Duckworth Pipeline Integrity Services, Inc.
1911 Quarterpath Drive
Richmond, Texas 77469
hnduck@houston.rr.com

To: Peter Katchmar
Fm: H. Noel Duckworth
Date: August 26, 2002

Ref: Olympic Pipeline – Bellingham, WA

As-Built Drawing of Relocation at Bellingham Water Treatment Plant
Figure 1.

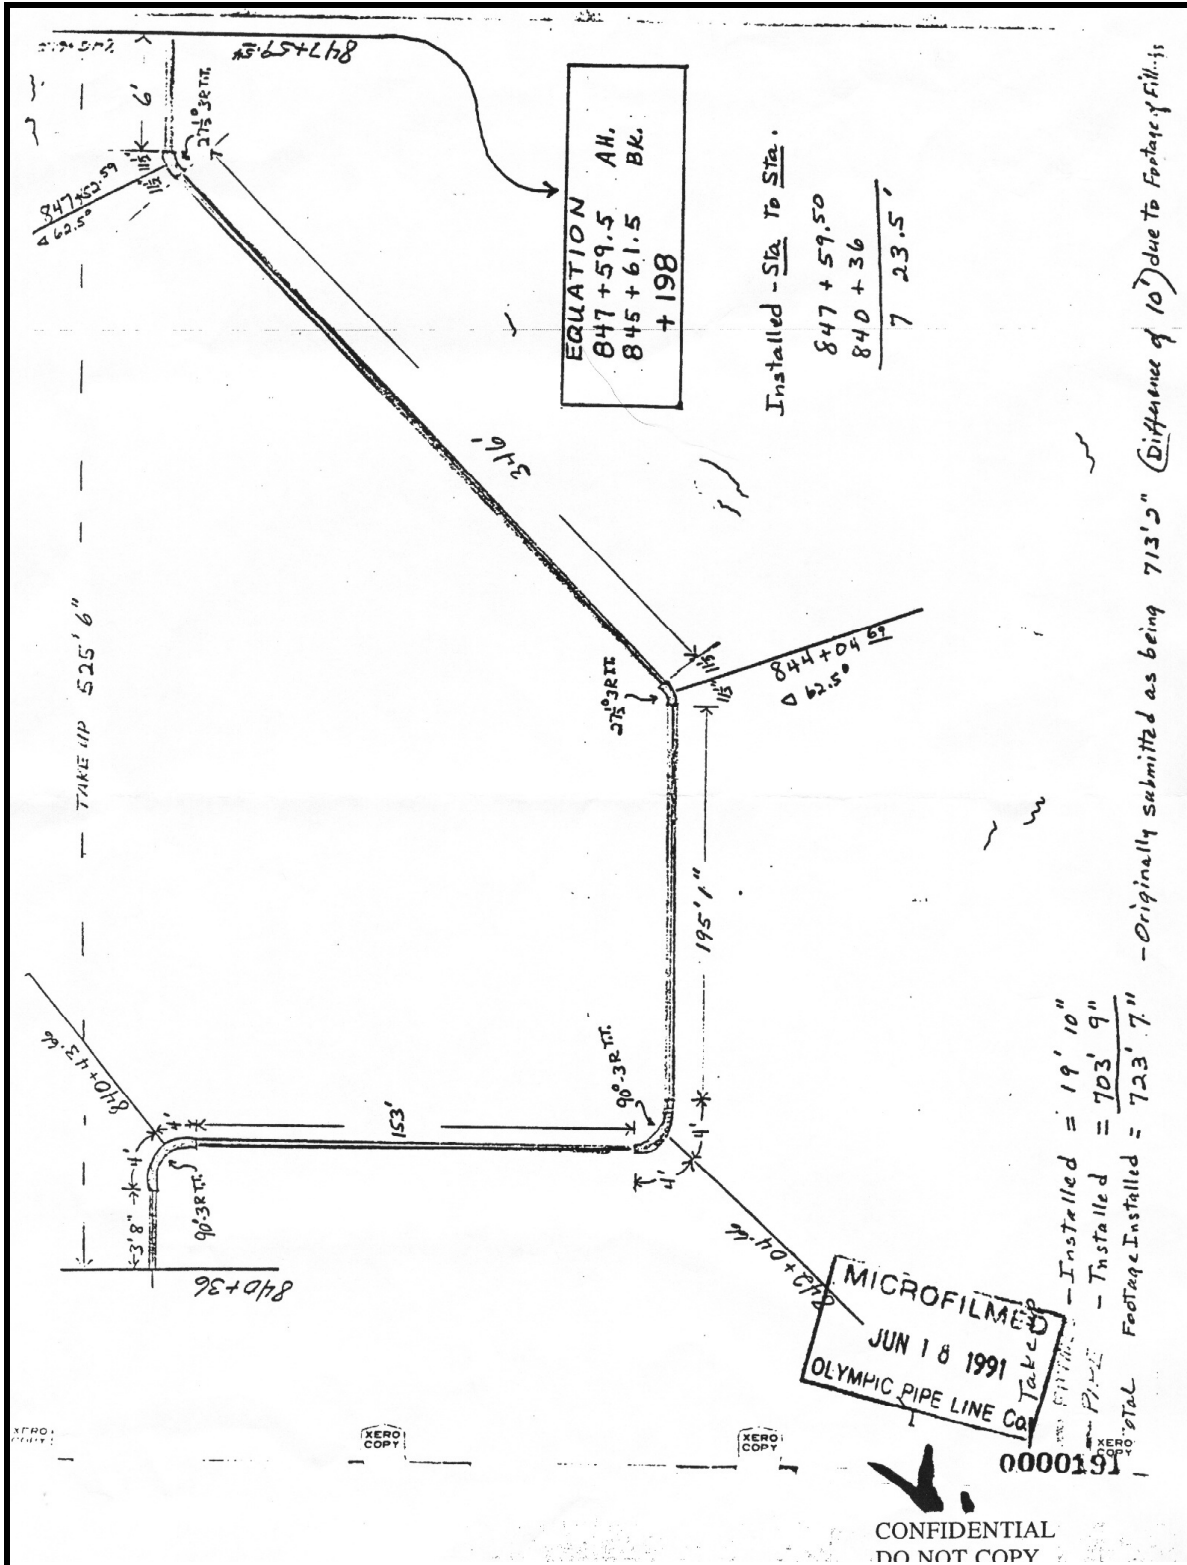
First, OPL knew exactly where the pipeline route was located in the area because they had relocated it for the proposed expansion at the City of Bellingham water treatment plant (Figure 1). At the conclusion of this relocation, OPL prepared an "as-built" drawing showing great detail as to the relocated position of the pipeline. This "as-built" drawing shows: a 3'8" pup joint beginning at OPL Station 840+36, a 90° 3R bend 8' long (*designated as "bend a" by HND for this report*) centered at OPL Station 840+43.66, a 153' straight run of pipe, another 90° 3R bend 8' long (*designated as "bend b" by HND for this report*) centered at OPL Station 842+04.66, a 195' 1" straight run of pipe, a 27.5° 3R bend 1' 11" long (*designated as "bend c" by HND for this report*) centered at OPL Station 844+04.69, a 346' straight run of pipe, another 27.5° 3R bend 1' 11" long (*designated as "bend d" by HND for this report*) centered at OPL Station 847+52, and another pup joint 6' long before the downstream tie-in point at OPL Station 847+59.54. The welds between the bends were not identified or located, so therefore, the only welds for which we know the locations are the tie-ins on each end of the relocation and the welds on either side of the four bends within the relocation. The length of each bend

is shown as measured along its arc length. The radius of curvature for the four bends is erroneously shown to be 3D (3 pipeline diameters). In 16" pipe, it would take an 8D bend to produce an arc length of 8' in a 90° bend.

The correlation of ILI data to this OPL-generated "as-built" will provide evidence as to the linear accuracy of the ILI systems employed. It will also provide confidence that the log location area corresponds to the failure location area due to the unique lengths of the bends, the approximate angle of the bends, the bend sequence, and the unique distances between the bends.

Scenario 1

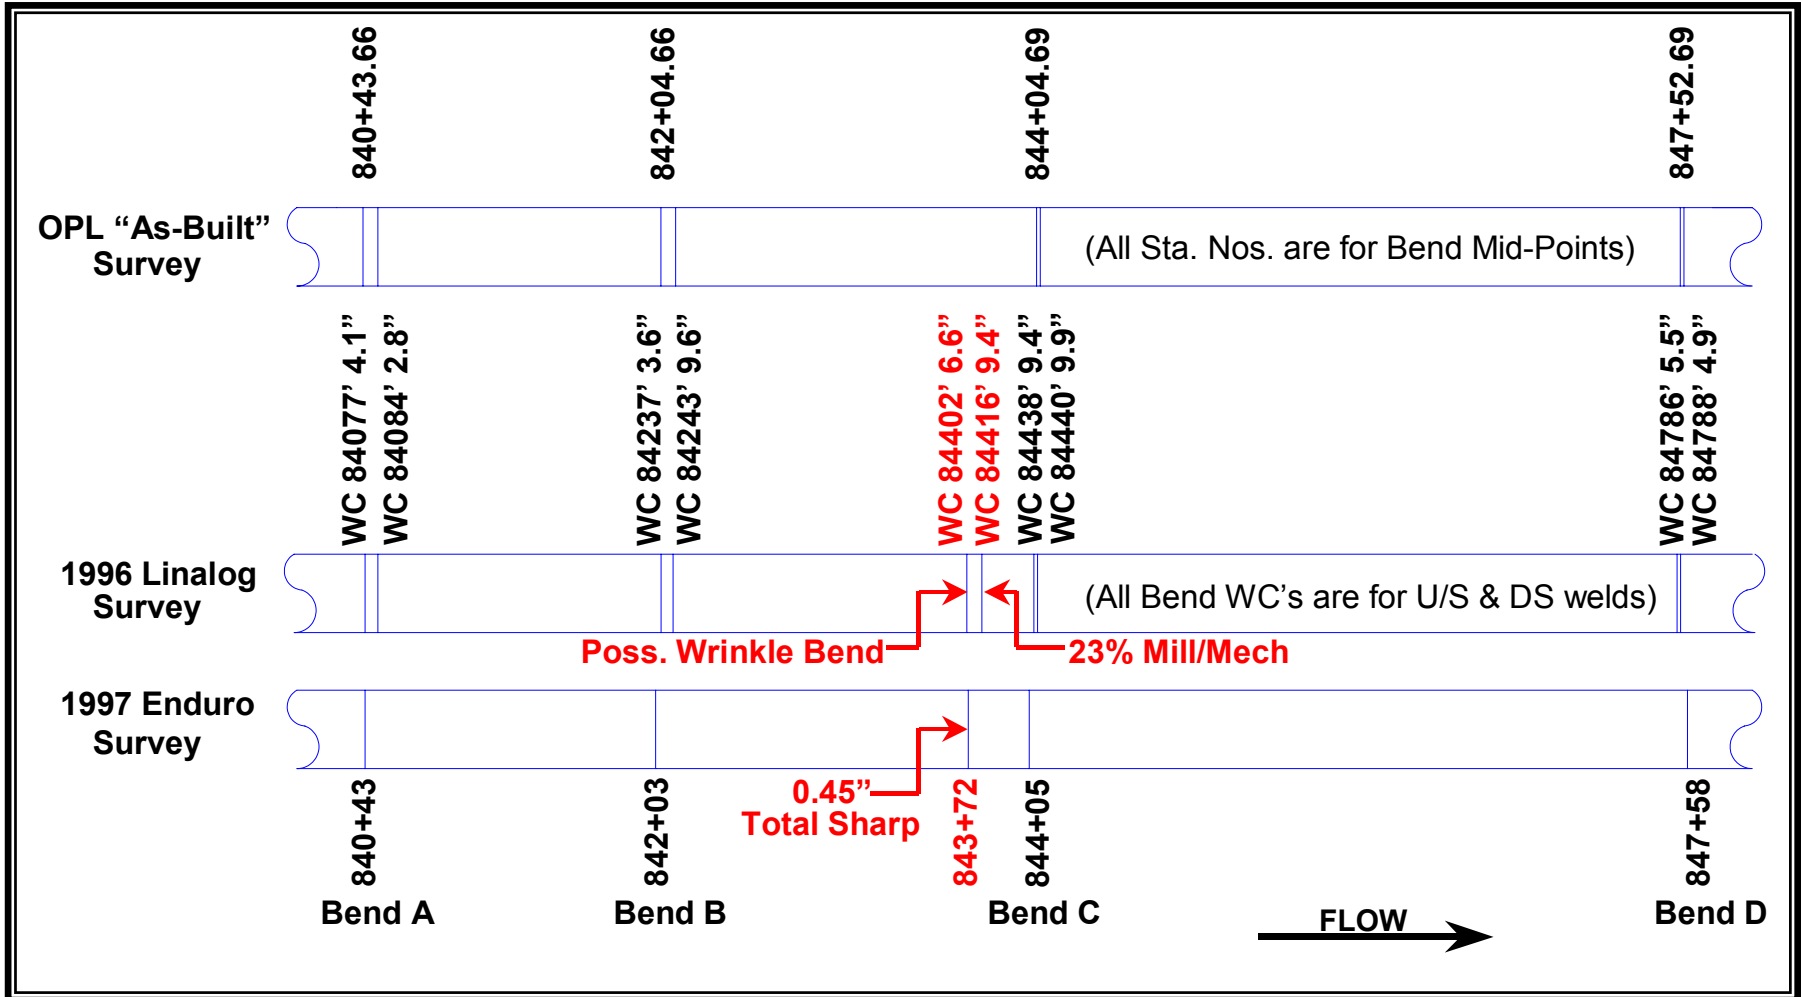
In Scenario 1., attached, I have aligned the station at Bend A on Enduro to the upstream weld of the same bend on the 1996 Linalog and in that case, the 0.45" Total Sharp reasonably aligns with the Possible Wrinkle Bend at WC 84402' 6.6" which we know to be the origin of failure. In Scenario 2., attached, I have aligned the station at Bend A on Enduro to the downstream weld of the same bend on the 1996 Linalog and in that case, the 0.45" Total Sharp reasonably aligns with the 23% metal loss at WC 84416' 9.4". Note how closely the Linalog data correlates to the "as-built" survey and how poorly, relatively speaking, the Enduro data correlates to the "as-built" data, regardless of which scenario you choose.
